Report to the
State of New Jersey Board of Public Utilities
I/M/O the Board's Investigation
Into Reliability Issues related to
Jersey Central Power & Light Company's
Morristown Underground System

BPU Docket No. EO11090526

February 3, 2012

Prepared by PJ Downes Associates, LLC

Figure 2

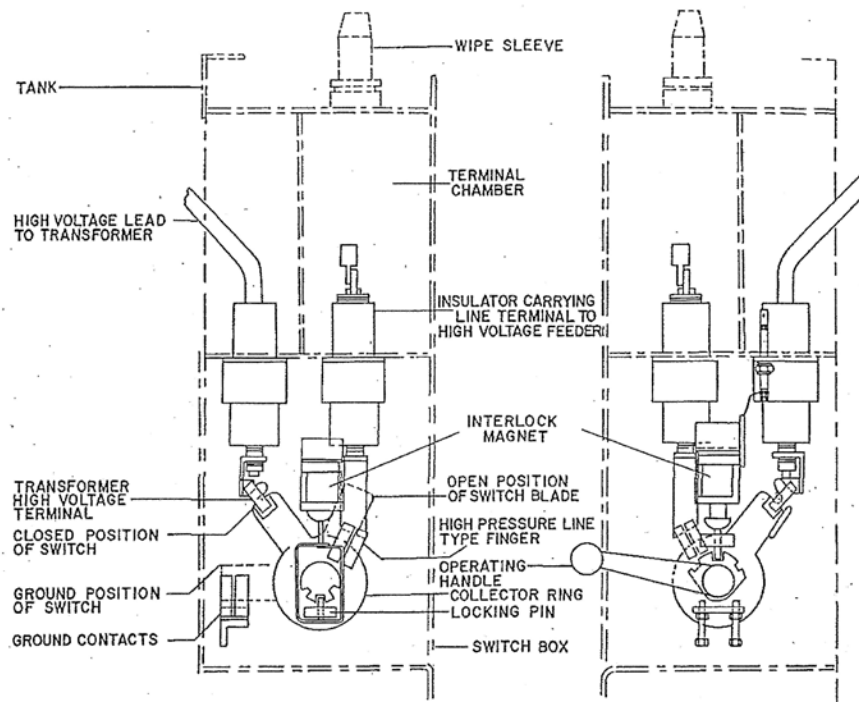
Photographs # 5 and # 6 that were taken by a member of the BPU staff show the failed transformer. It is appropriate that additional preventive maintenance should be conducted on all transformers in the Morristown Network that use a cable termination compartment for connection to the primary circuit.

Initially it will be necessary to identify the number and location of these transformers. The maintenance should include the following items:

1. Sample the oil from the cable termination compartment and test. This will allow data collection regarding any deterioration of the oil up to this time.
2. Drain oil, remove terminal chamber cover, and inspect the compartment and cable terminations for signs of deterioration. If necessary make repairs. Reinstall terminal chamber cover and air test the compartment for leaks. If necessary make repairs.
3. Fill the compartment with Cooper Power System Envirotemp FR3 Fluid or an equivalent dielectric fluid. This is a non-petroleum product with a higher flash point than petroleum based products.

1. Initiate the program and complete refurbishing of transformers with cable termination compartments by June 1, 2012. The Company has agreed to this recommendation.
